# Zoning Staff Report

**Case Number:** SP-22-010

**Proposed Use:** Amend Required Site Plan of PD574 for lots 1R and 3R for multifamily and mixed-use

# MONTGOMERY PLAZA SITE PLAN

# Exhibit of Public Access Easements

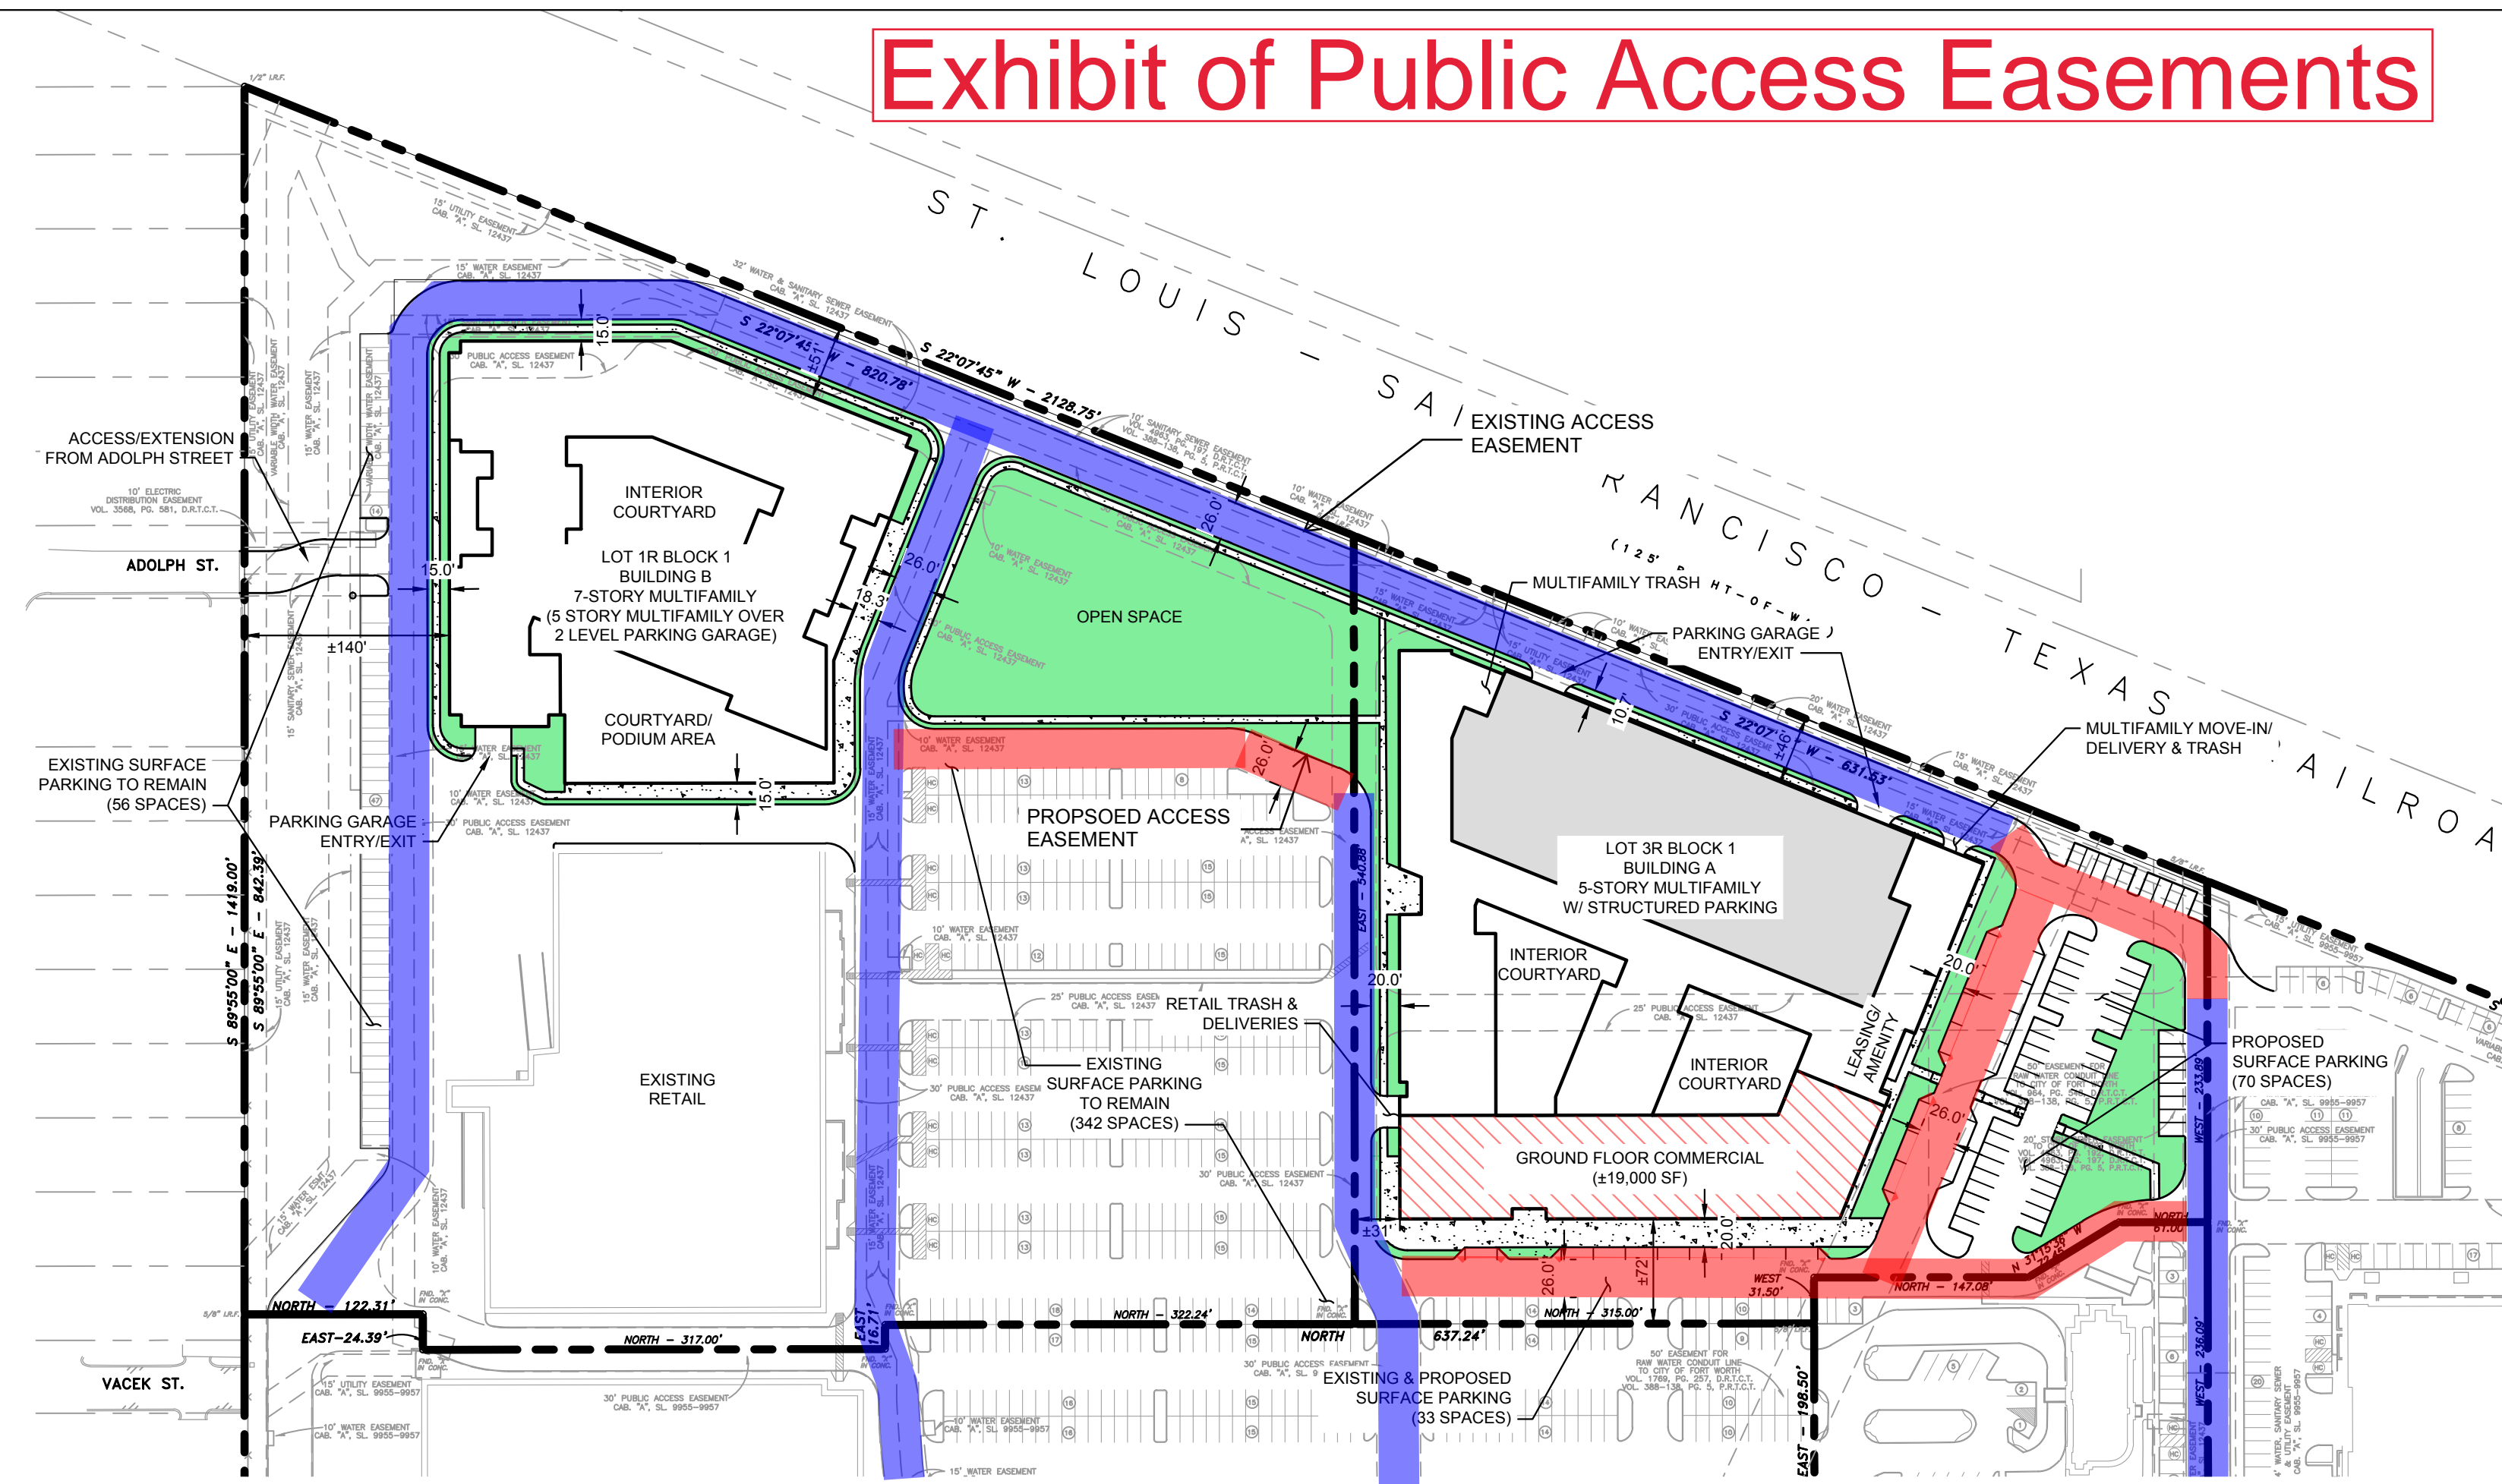
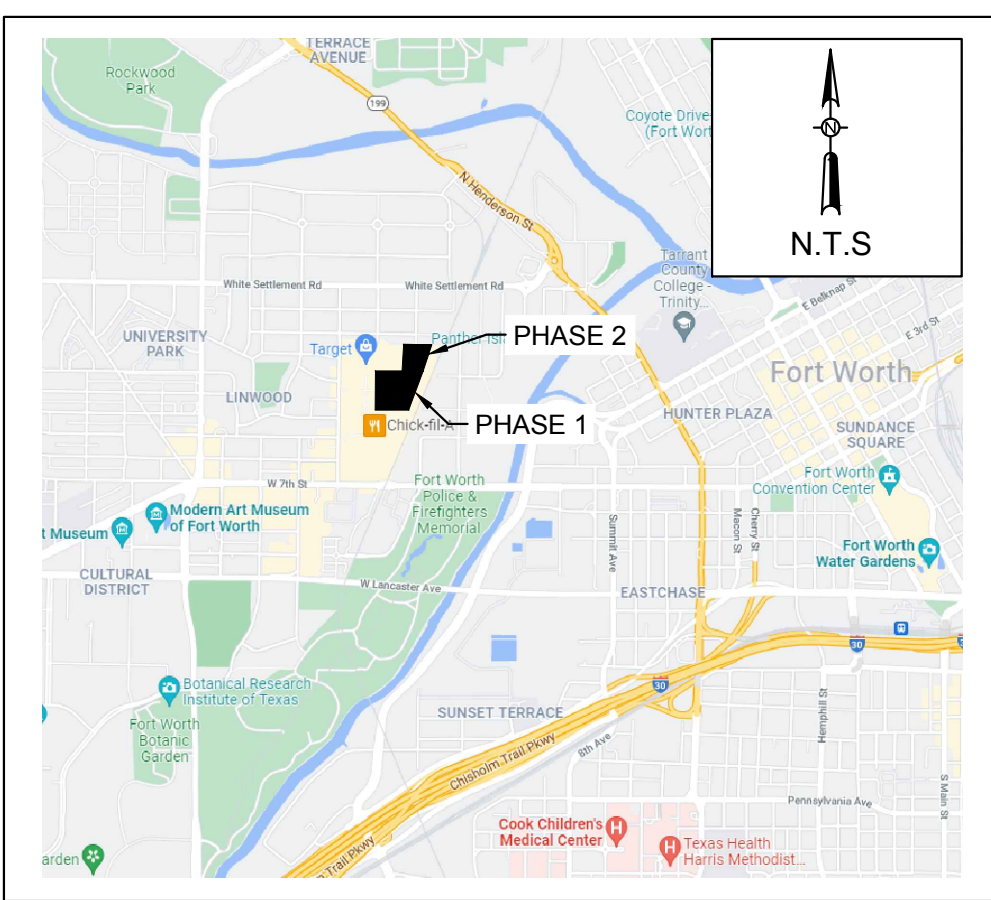
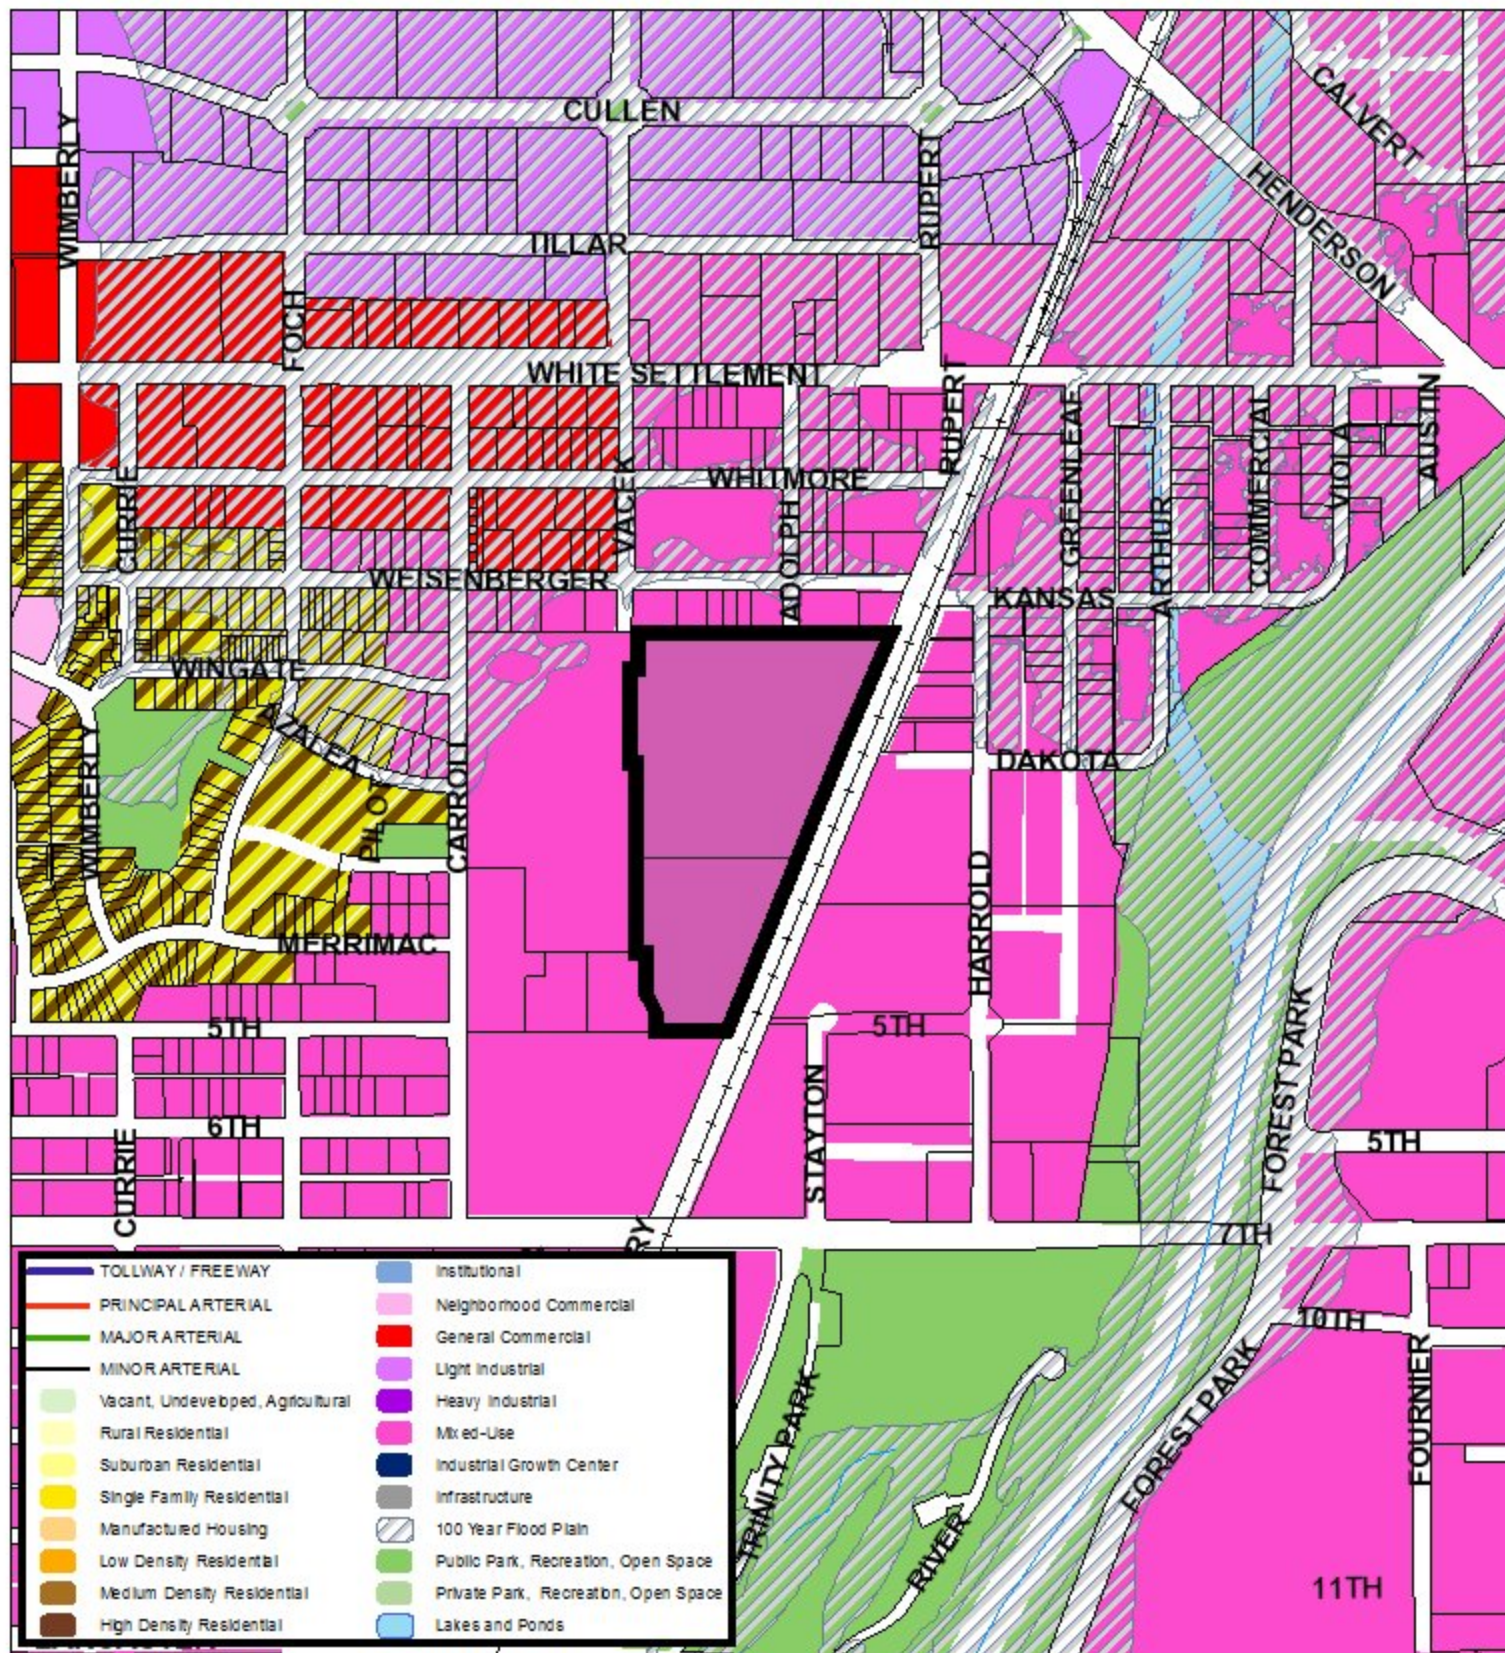
- Plat was not provided with the application documents, but an exhibit of existing and proposed access easements was provided. Platted Public Access Easements affect requirements of the MU-2 Ordinance, such as, but not limited to, the following:
